THE HIGHLINE AT UNION MARKET

320 FLORIDA AVENUE, N.E.
WASHINGTON DC

March 25, 2016
PUD MINOR MODIFICATION FOR PUD 15-01

P-2 GARAGE PLAN - APPROVED & PROPOSED

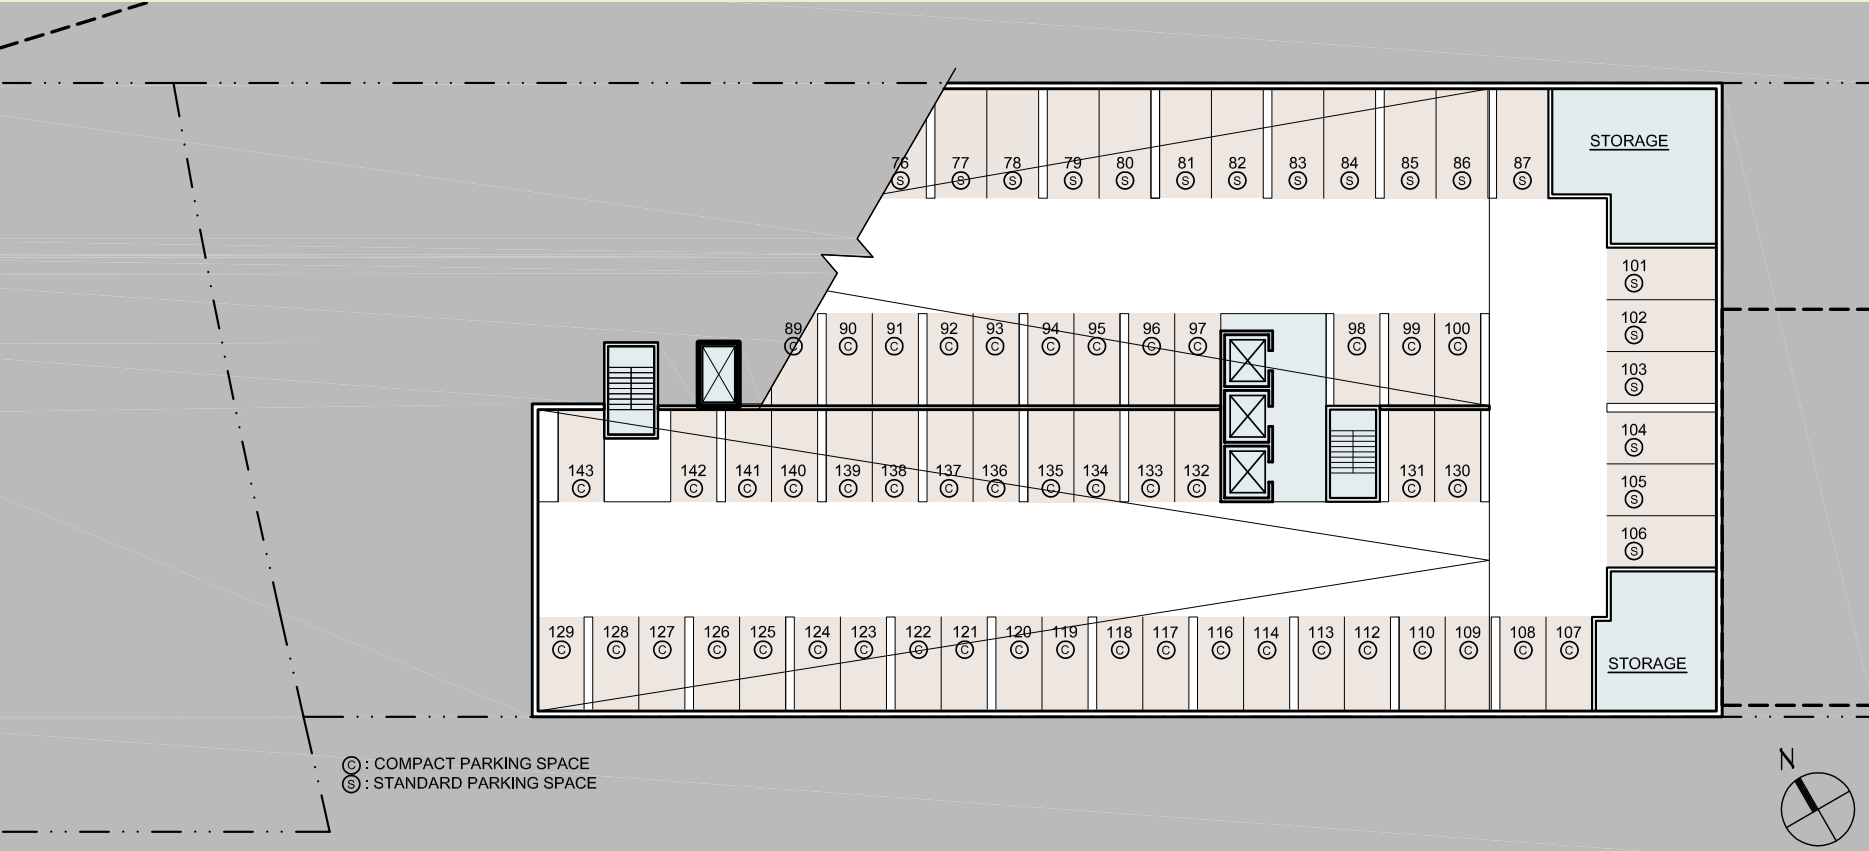
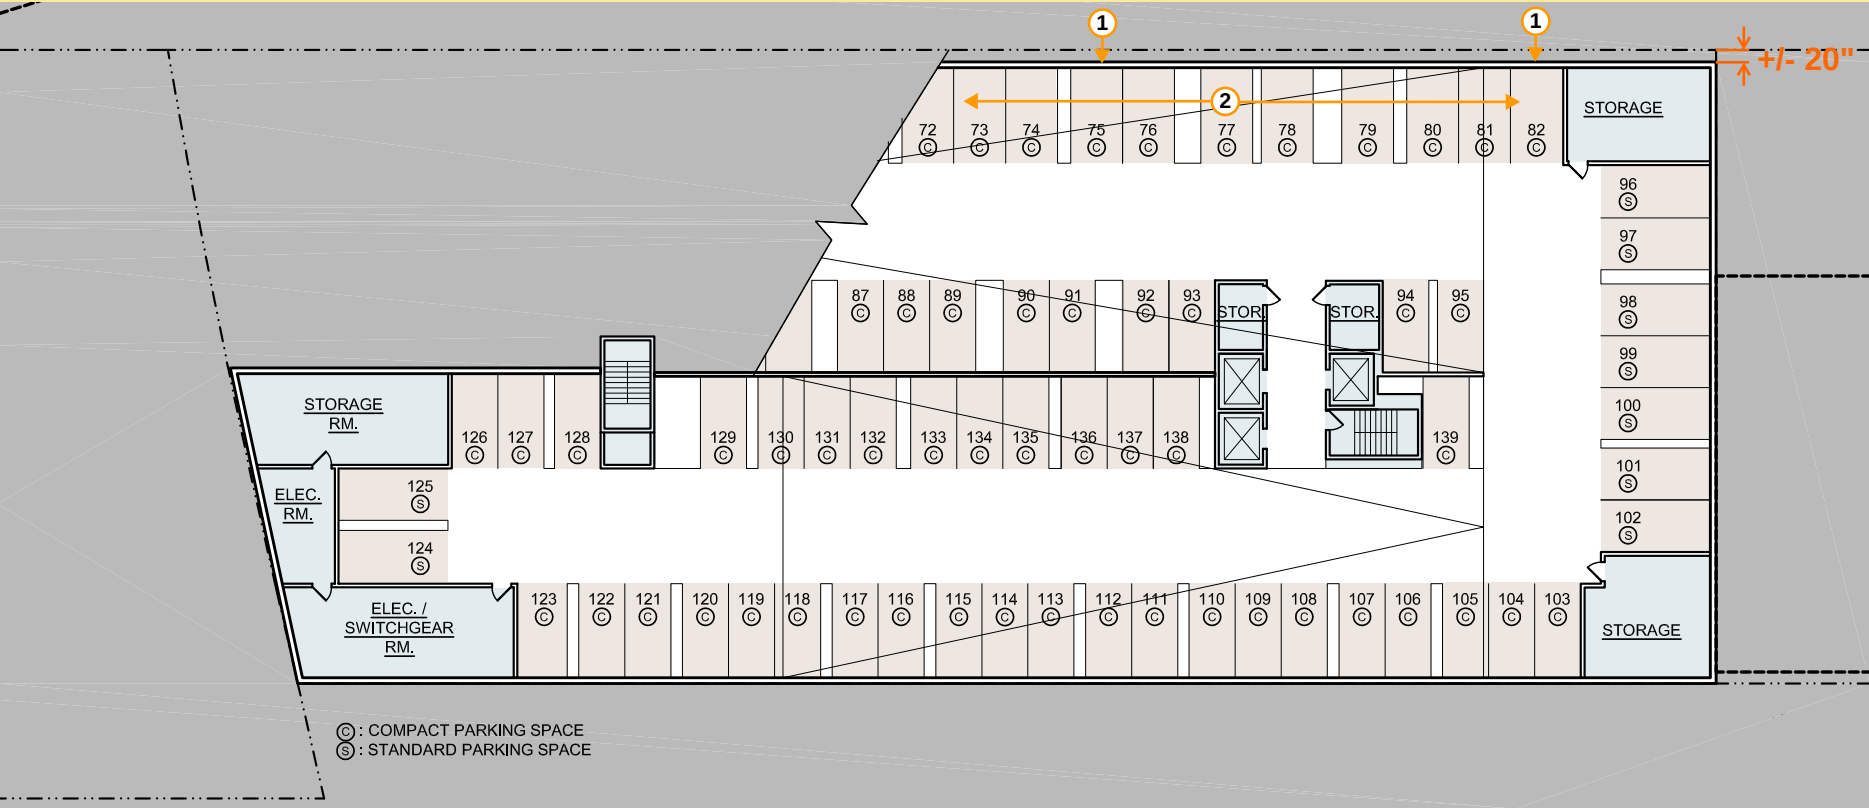
* COMPACT PARKING RATIO INCREASED FROM 63% TO 86%, REPRESENTING ADDITIONAL RELIEF REQUIRED, DUE TO NECESSARY SHIFT IN FOUNDATION WALL. ADDITIONAL COMPACT SPACES WILL MAINTAIN STANDARD PARKING SPACE WIDTH OF 9ft.

1. FOUNDATION WALL SHIFT +/- 20"
2. 9 ft WIDE COMPACT PARKING SPACES

P-1 GARAGE PLAN - **APPROVED** & **PROPOSED**

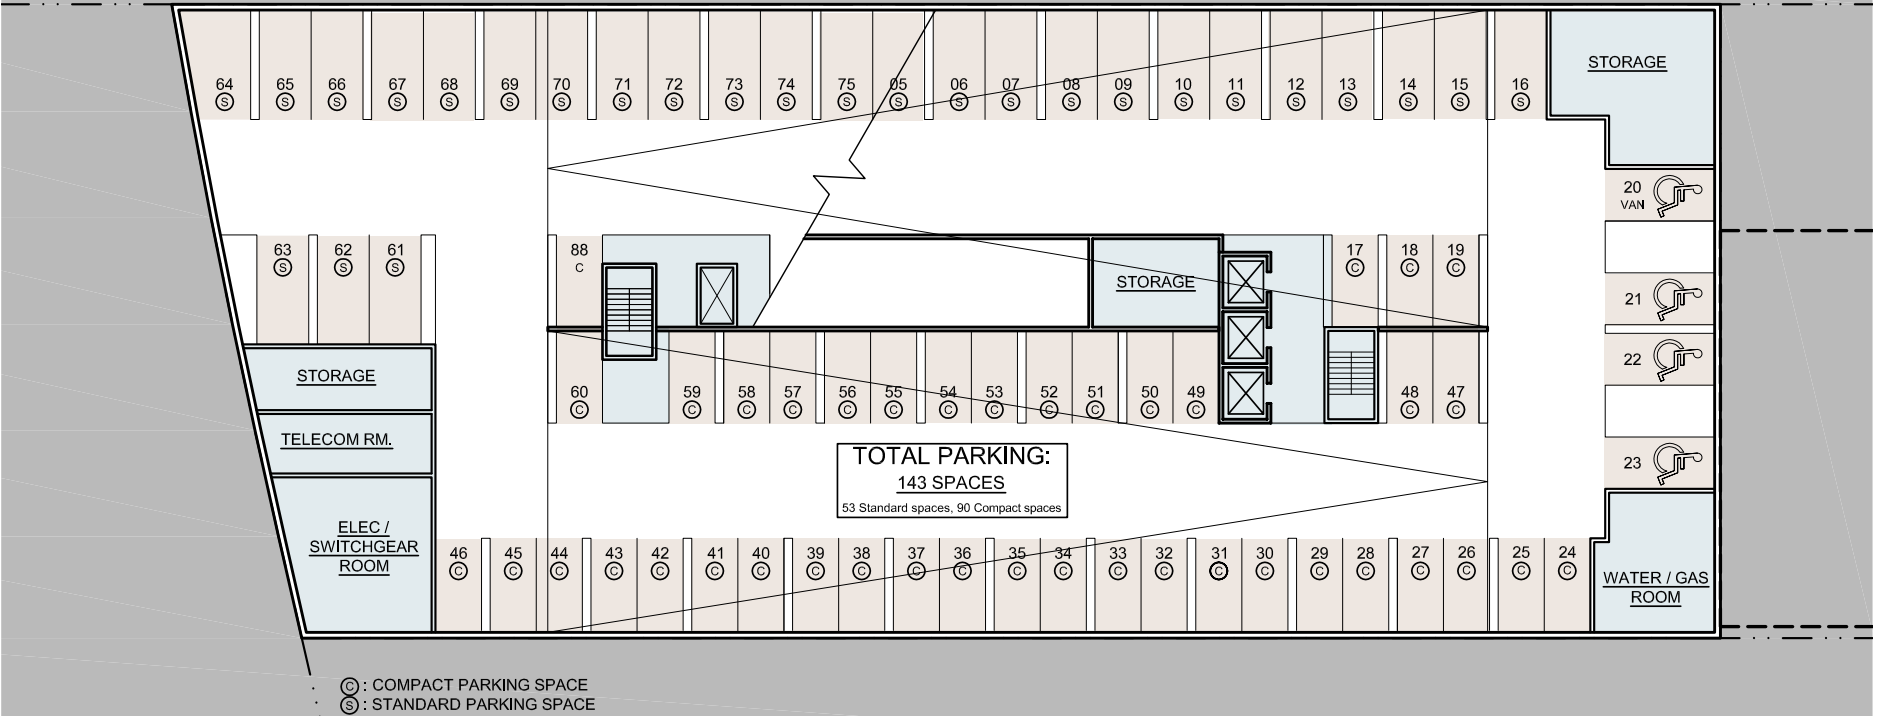
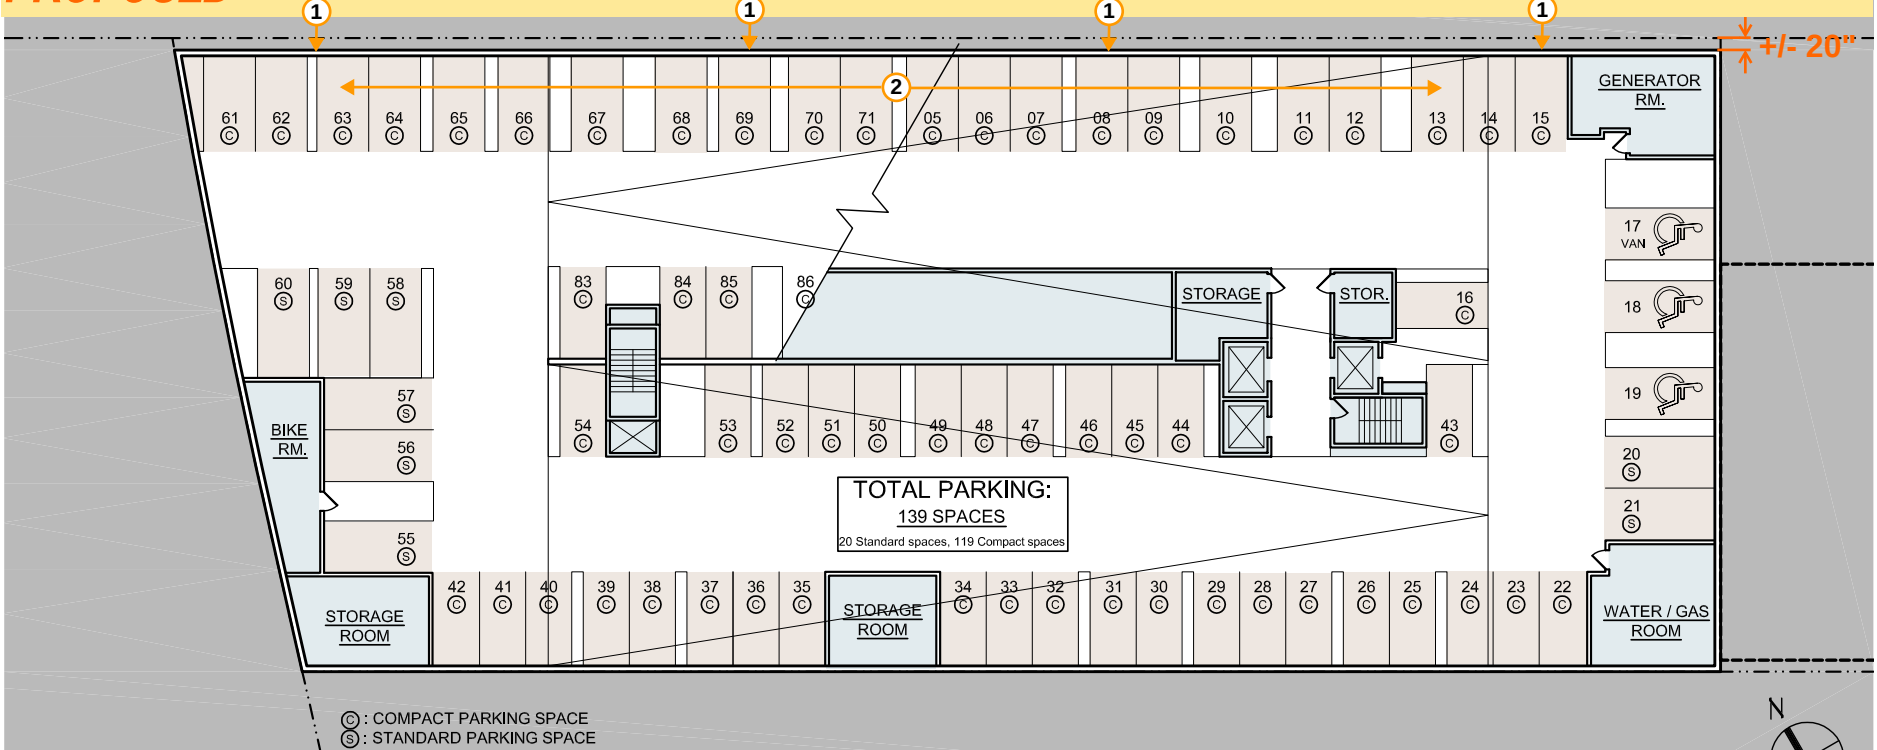
- * COMPACT PARKING RATIO INCREASED FROM 63% TO 86%, REPRESENTING ADDITIONAL RELIEF REQUIRED, DUE TO NECESSARY SHIFT IN FOUNDATION WALL. ADDITIONAL COMPACT SPACES WILL MAINTAIN STANDARD PARKING SPACE WIDTH OF 9ft.
- 1. FOUNDATION WALL SHIFT +/- 20"
- 2. 9 ft WIDE COMPACT PARKING SPACES

PENTHOUSE FLOOR PLAN - APPROVED & PROPOSED

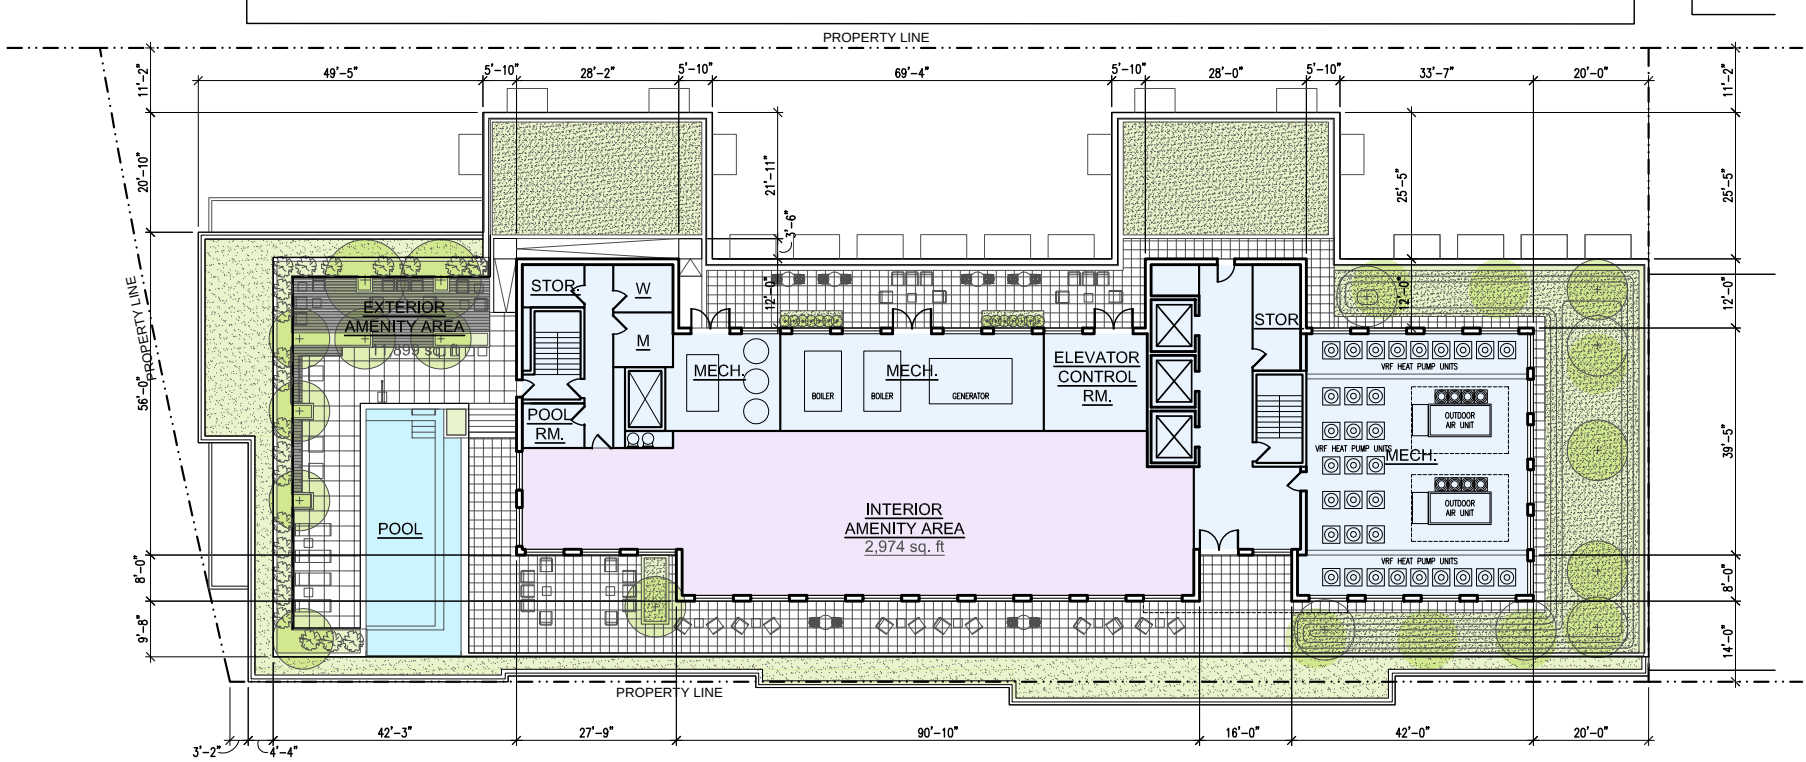
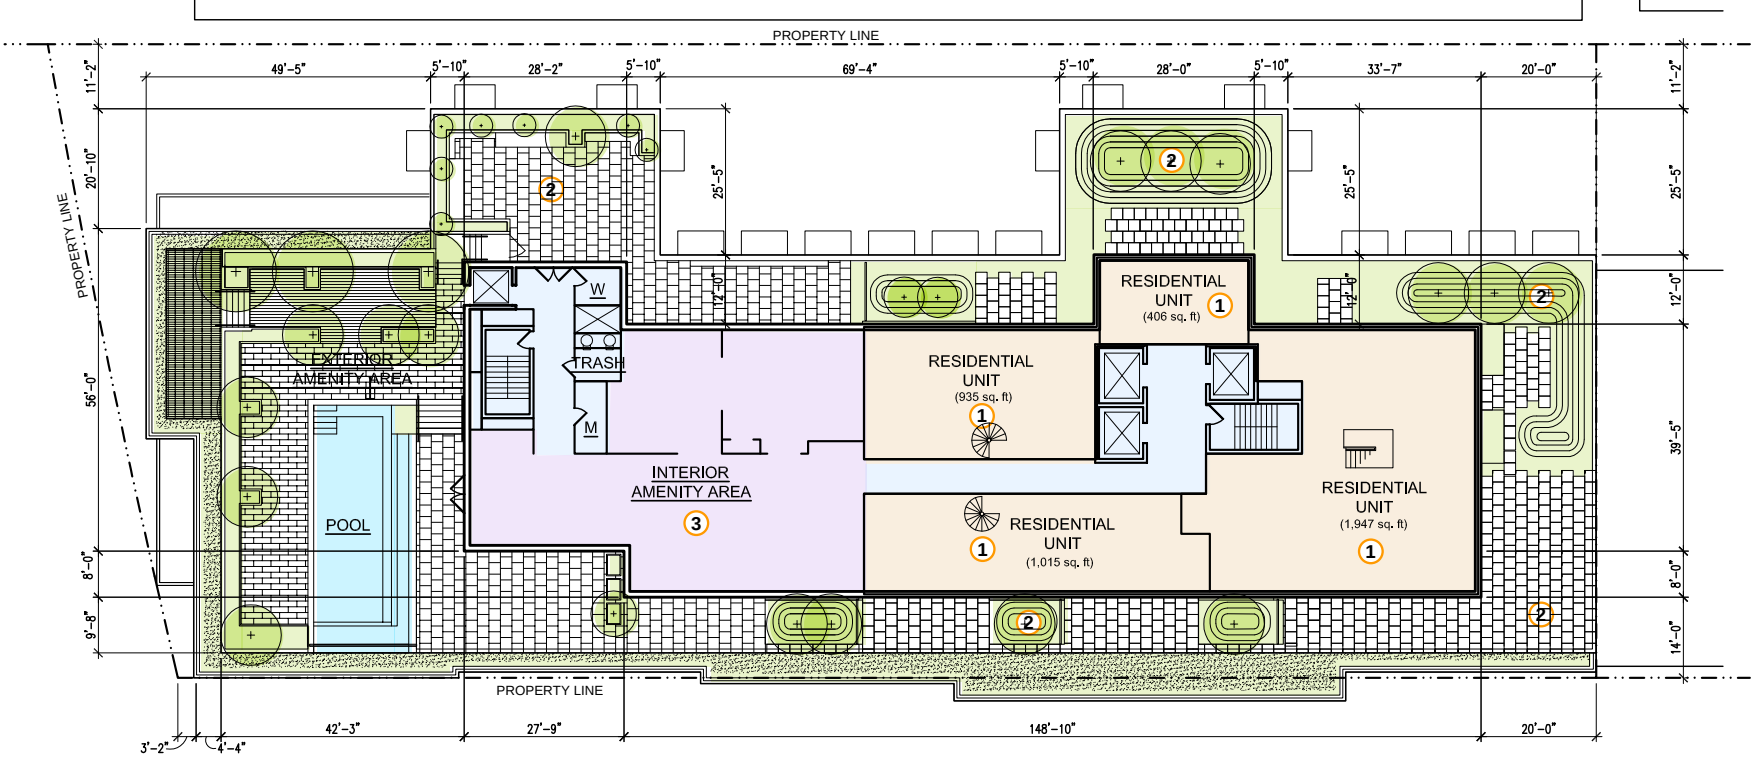
- * CHANGES TO ROOF STRUCTURE TO INCORPORATE ZC ORDER NO. 14-13
- 1. NEW PENTHOUSE RESIDENTIAL UNIT
- 2. REVISED LANDSCAPE
- 3. NEW INTERIOR AMENITY AREA LOCATION

APPROVED	PROPOSED
Over at least 2" and less than 8" of growth medium	9,450 sf	3,300 sf
Over at least 8" of growth medium	0 sf	5,324 sf
Green Area Ratio Score	0.212	0.212

- Increase the net residential area by 5,593 sf.
- Increase unit count: 4 additional units.
- Increase in required IZ net residential area per Sections 2603.2 and 2603.10 @ 50% of AMI = 448 sq. ft.
- The Applicant proposes to provide an additional I.Z. Unit (448sq. ft. minimum) @50% of AMI:

PENTHOUSE FLOOR PLAN - MEZZANINE - PROPOSED

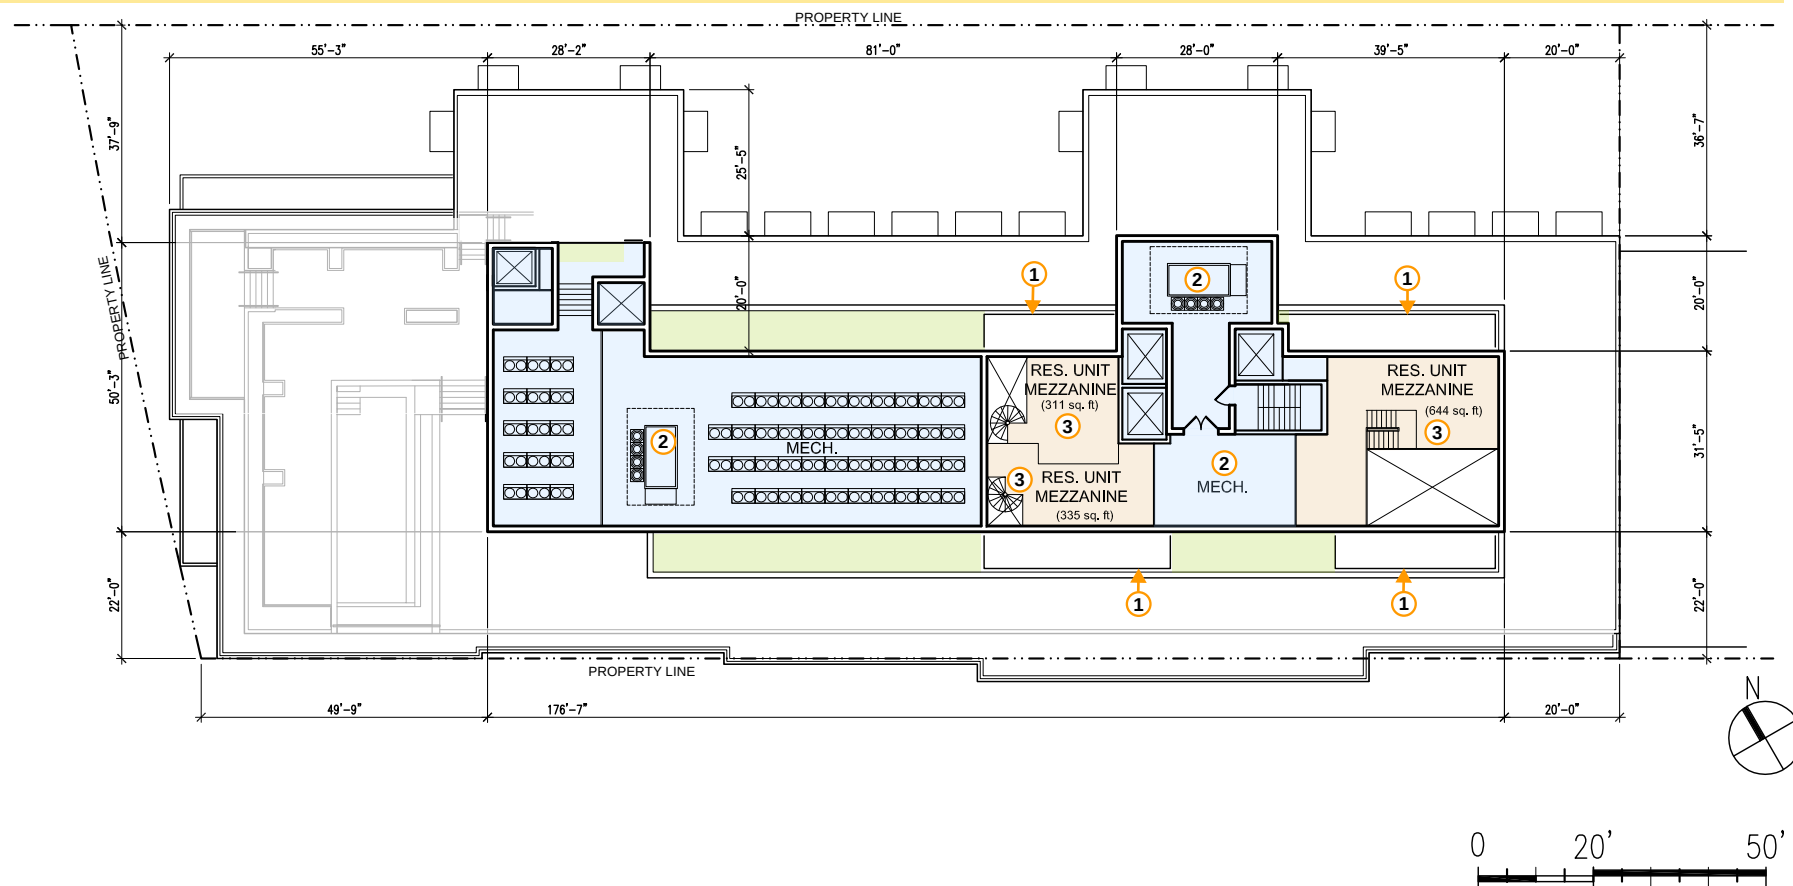
- * CHANGES TO ROOF STRUCTURE TO INCORPORATE ZC ORDER NO. 14-13
- 1. NEW RAILING (1:1 SETBACK PROVIDED)
- 2. NEW MECHANICAL EQUIPMENT LOCATION
- 3. NEW RESIDENTIAL UNITS MEZZANINES (AREA DO NOT EXCEED 1/3 OF THE SPACE BELOW).
